Replacing the Actuator for Ford 6.4L Powerstroke V2S and HP Turbos

Application Ford 6.4L Powerstroke V2S and HP Turbos

SRA vs. CBA Style Actuators

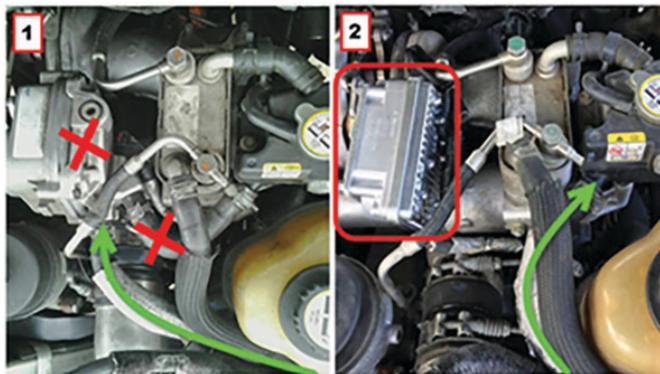
The original SRA has been discontinued and is no longer available for the Ford 6.4L Powerstroke V2S turbo systems sold between 2008 and 2010.

This photo shows the original actuator and coolant line arrangement.

This photo shows the new actuator with the coolant line rerouted directly to the coolant reservoir. The coolant block is attached to the original SRA and the short hose that connects the coolant block to the reservoir (no longer being used). The shielded hose (marked with the green arrow) moves from the coolant block connection to the reservoir connection.

Action Step: Remove the actuator coolant block and the short hose that went from the old actuator coolant block to the reservoir.
